Access Compliance Report

Public Rights-of-Way

(Curb Ramps)

Intersection ID: 27113	Main Street: ALEXANDER_VALLEY_DR	Cross Street: PROVIDENCE_RD	Location: NW
ADA ID: C6744CB68115	Ramp Type: PerpDiag	Initial Pass/Fail: Fail	Overall Compliance: No
Severity Score: 33.75			
Codes/Mitigation Info/Possible Solution		Field Measurements/Component Compliance

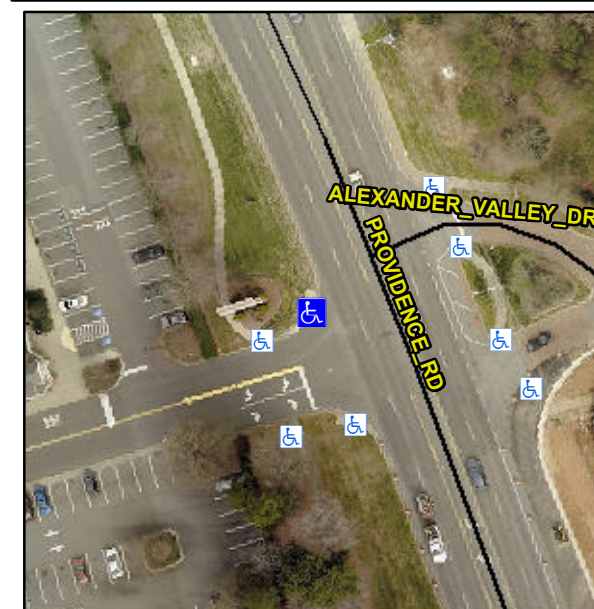
Not Found, R304.5.1, R304.5.3

Compliance	Description	Data	Compliance	Description	Data
N/A	Ramp Length (in)	60.0	Yes	Ramp Slope (%)	5.3
No	Ramp Width (in)	46.0	No	Ramp XSlope (%)	8.8
N/A	Flare Type LT	N/A	N/A	Flare Type RT	N/A
N/A	Flare Slope LT (%)	N/A	N/A	Flare Slope RT (%)	N/A
N/A	Flare Traversable LT?	N/A	N/A	Flare Traversable RT?	N/A
N/A	Landing Length (in)	N/A	N/A	DWS Provided?	N/A
N/A	Landing Width (in)	N/A	N/A	DWS Contrast?	N/A
N/A	Landing Slope (%)	N/A	N/A	DWS Length (in)	N/A
N/A	Landing X Slope (%)	N/A	N/A	DWS Full Width?	N/A
N/A	Landing Curb? (Y/N)	N/A	N/A	DWS Offset (in)	N/A
N/A	Shared Landing?	N/A			
N/A	Gutter Ponding?	N/A	N/A	Gutter Slope (%)	N/A
N/A	Gutter Lip Ht (in)	N/A	N/A	Gutter X Slope (%)	N/A
N/A	Painted X Walk1?	No	N/A	Painted X Walk2?	No
	X Walk 1 Direction	To E		X Walk 2 Direction	To S
N/A	X Walk 1 Width (in)	N/A	N/A	X Walk 2 Width (in)	N/A
	X Walk 1 Slope (%)	0.5		X Walk 2 Slope (%)	4.8
	X Walk 1 X Slope (%)	14.1		X Walk 2 X Slope (%)	3.1

Remove & Replace Curb Ramp With Two New Directional Ramps or Equivalent.
